ADDENDUM

RFB NO. 317012 - ADDENDUM NO. 1

DAY RESOURCE CENTER REMODELING

1 3.06 DEMONSTRATION

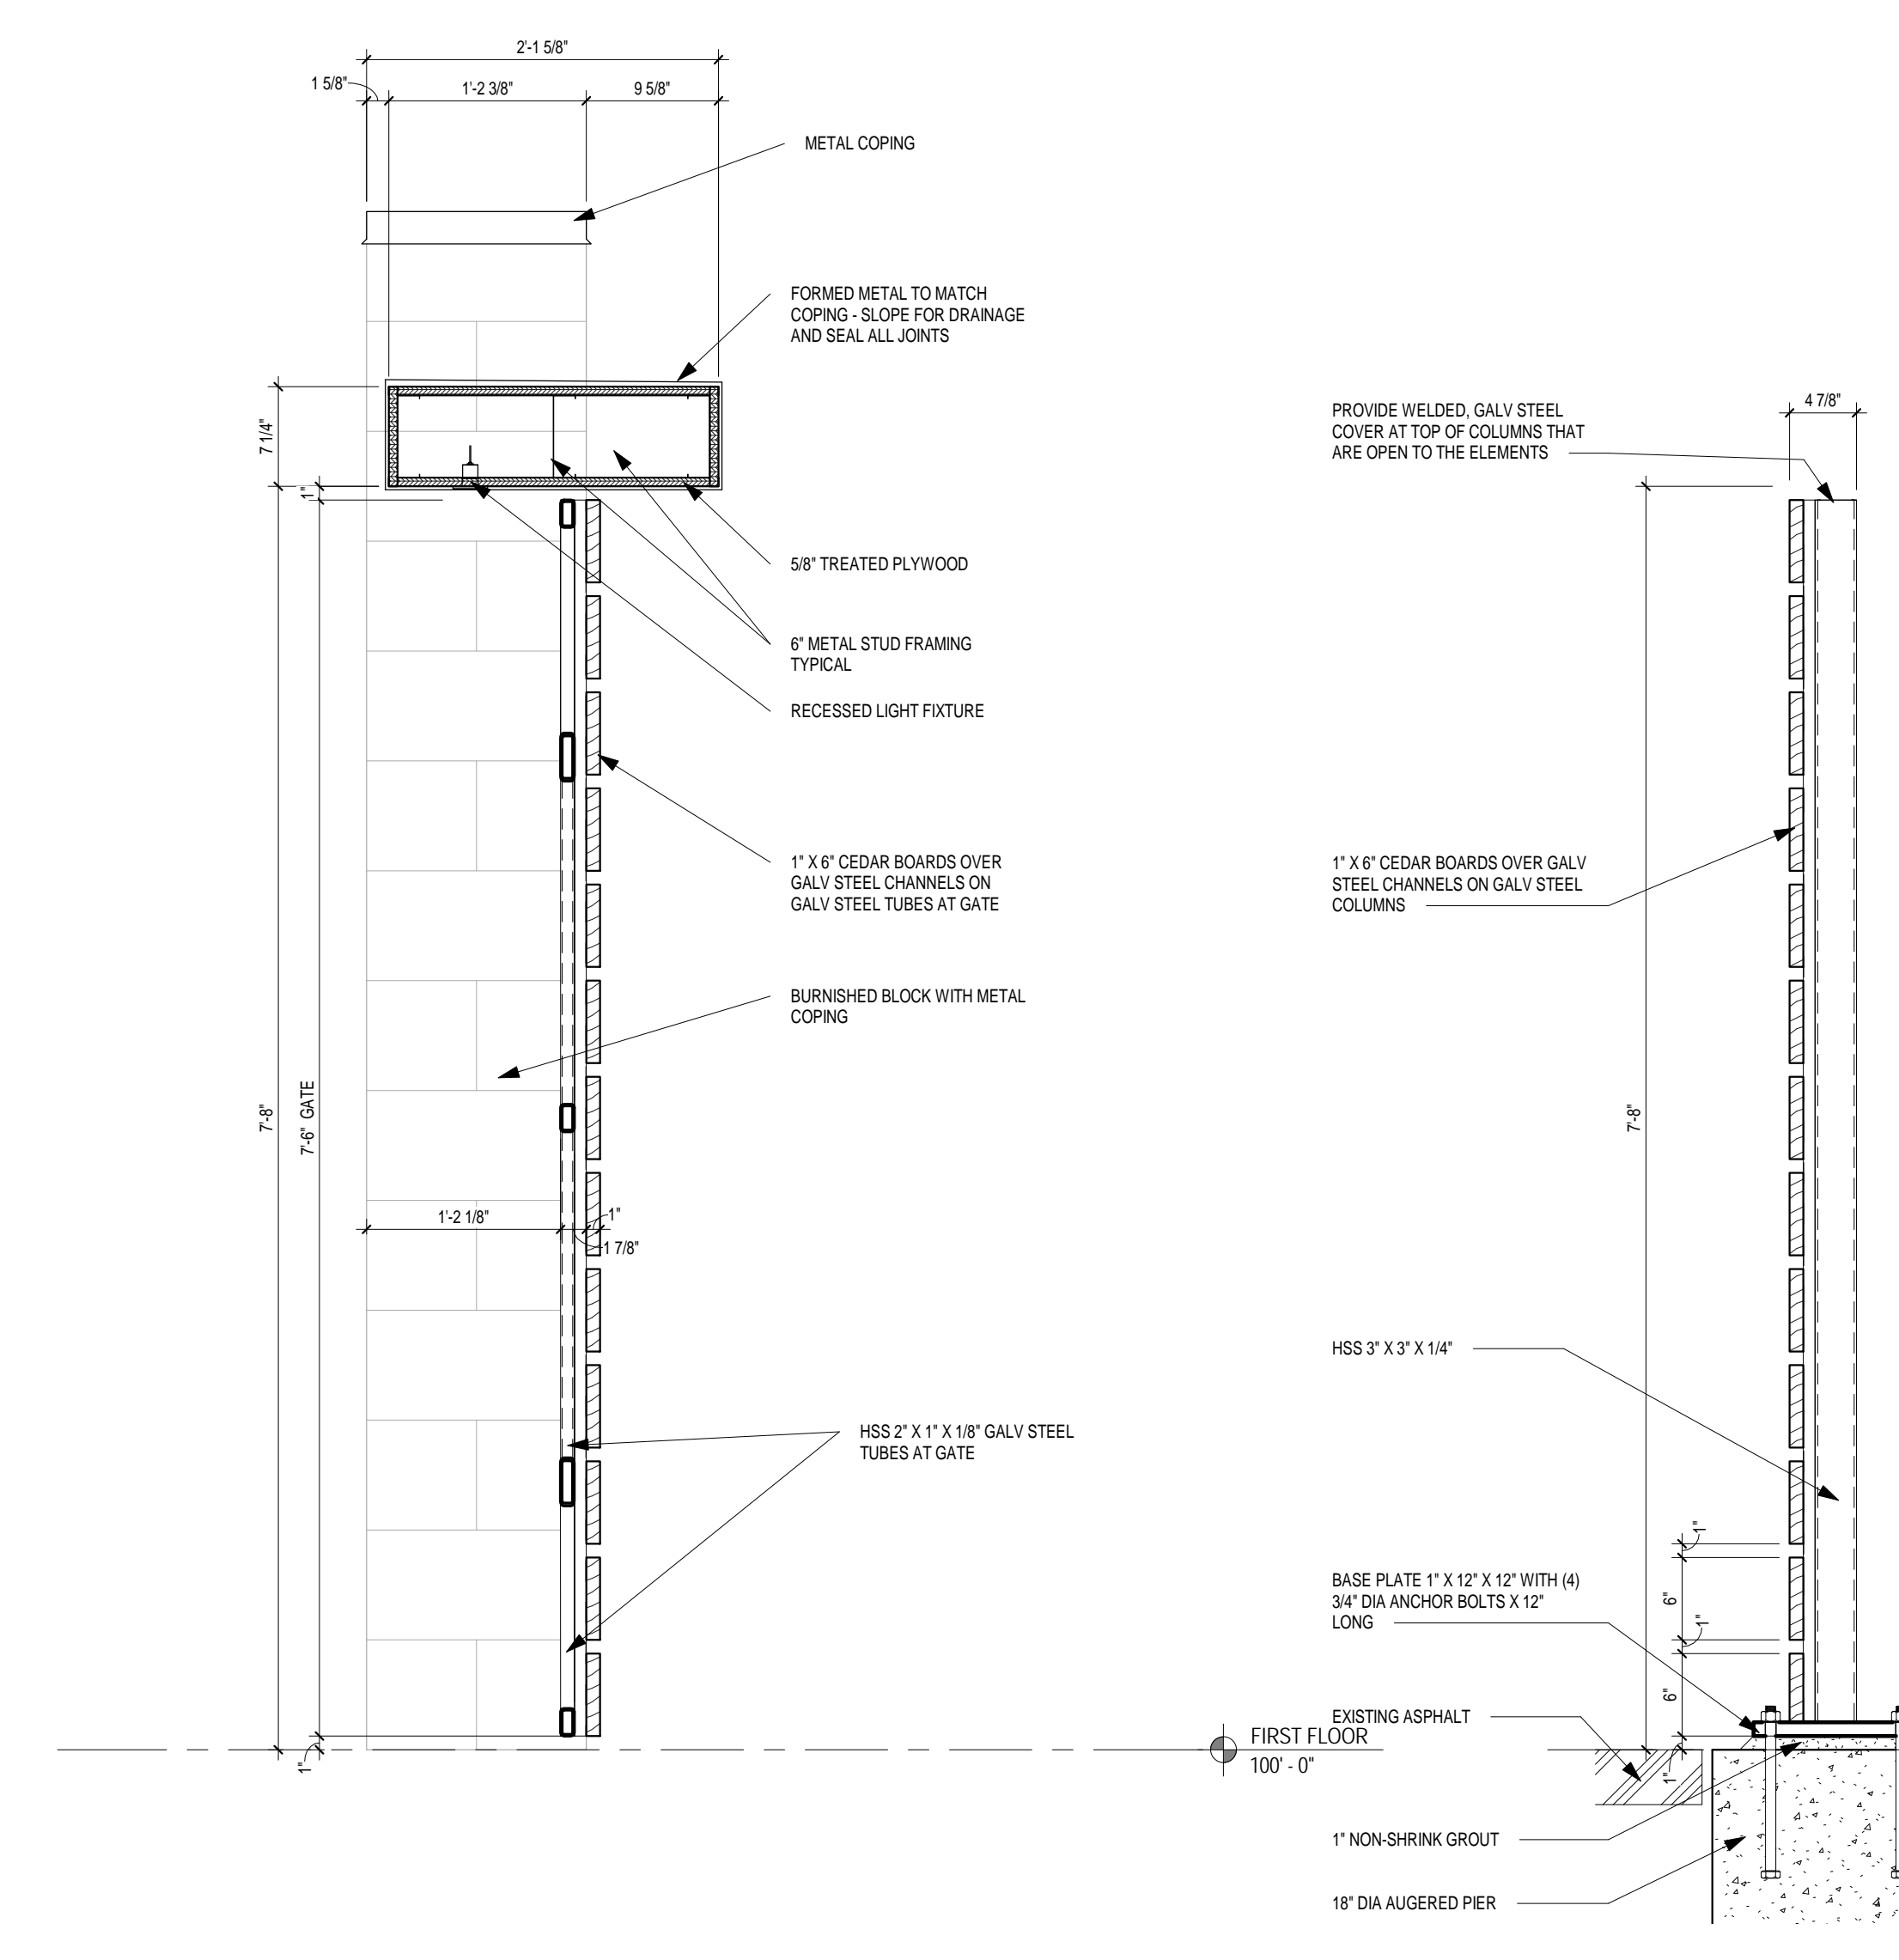
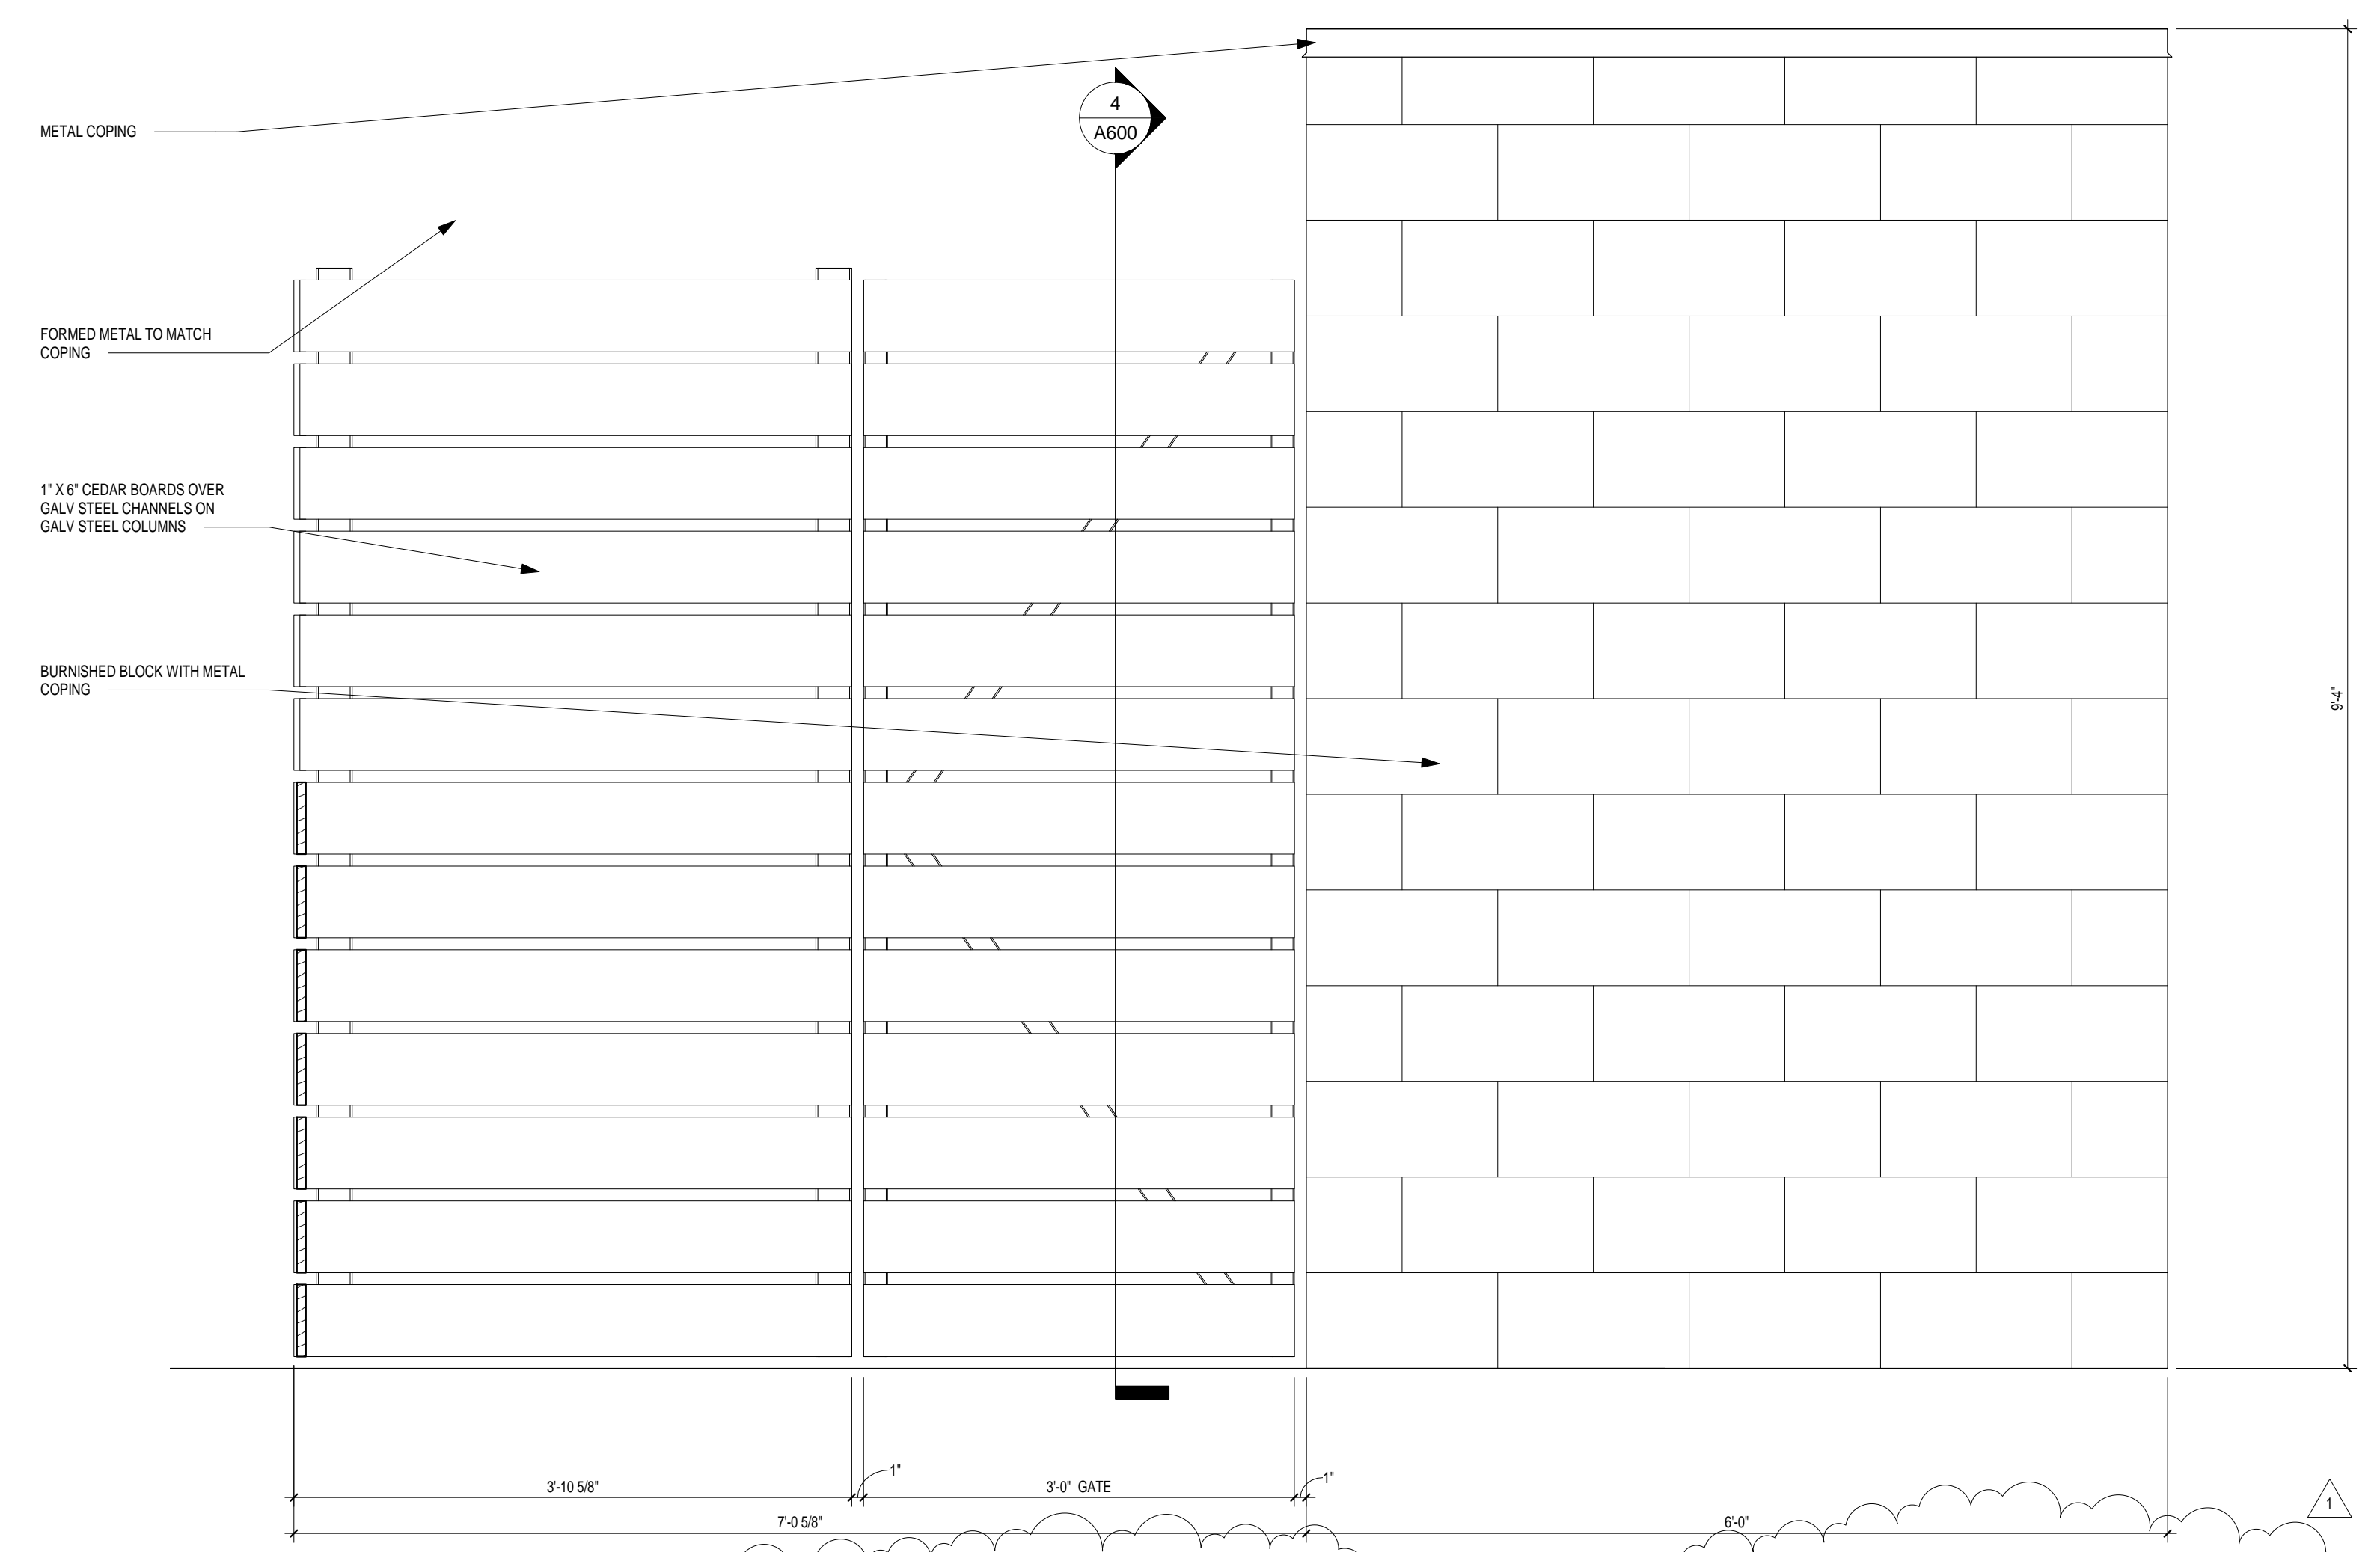
- b. Second Floor Resource Center 205: “Extend soffit at exposed structure plan north approximately 2’-0”, V.I.F. to conceal ductwork.”
6. A600
 - a. Refer to attached revised A600 for revised covered fence detail and additional concrete walk detail (Alternate Bid A).
